ADDENDUM No. 1

RFP No. 23-05

2023 Miscellaneous Utility Projects

CARMEL STREET WATER MAIN- STA 308+50 TO P.O.E.

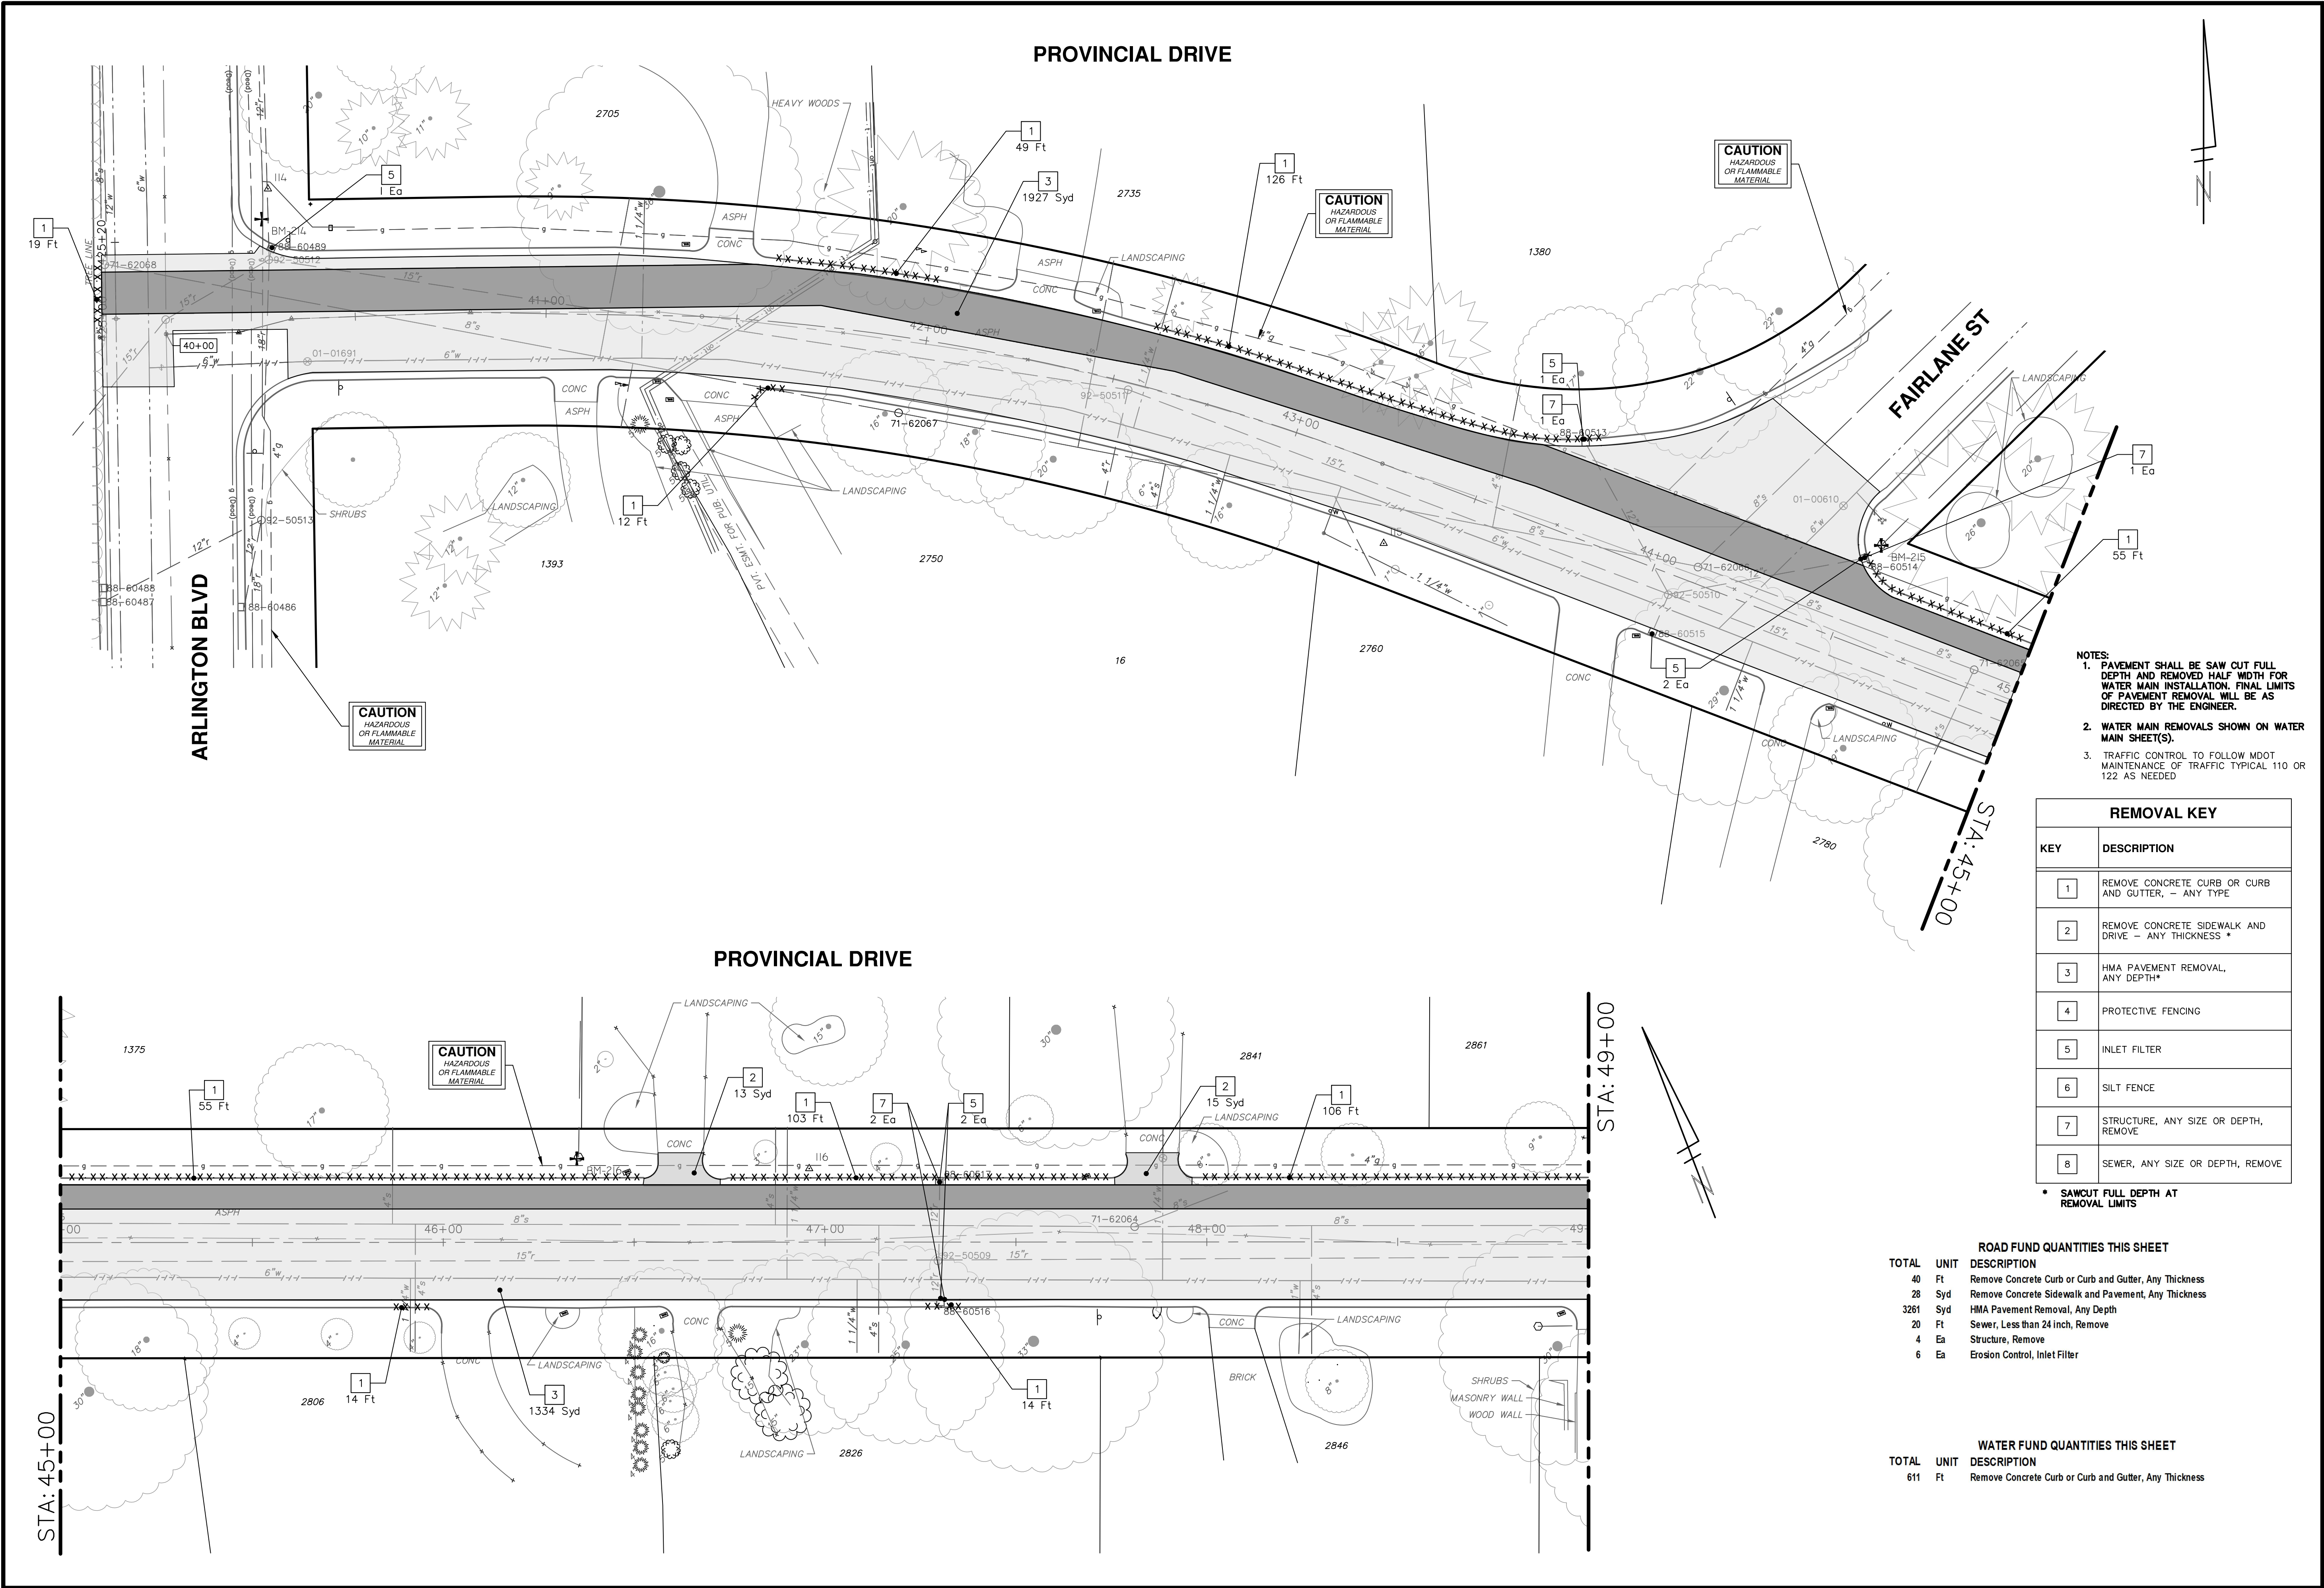
Section/Page(s)	Change
Replace Plan Set in its entirety	Minor quantity revisions throughout Added stormwater curb drain on Sheet 33 Revisions to water main profile at Towner on Sheet 28 Added sanitary sewer replacement along N 7th on Sheet 40
Replace Bid Form, 15 to 18	Quantity updates to reflect plan changes
New Content, DS-113 to DS-114	Curb Drain Specification
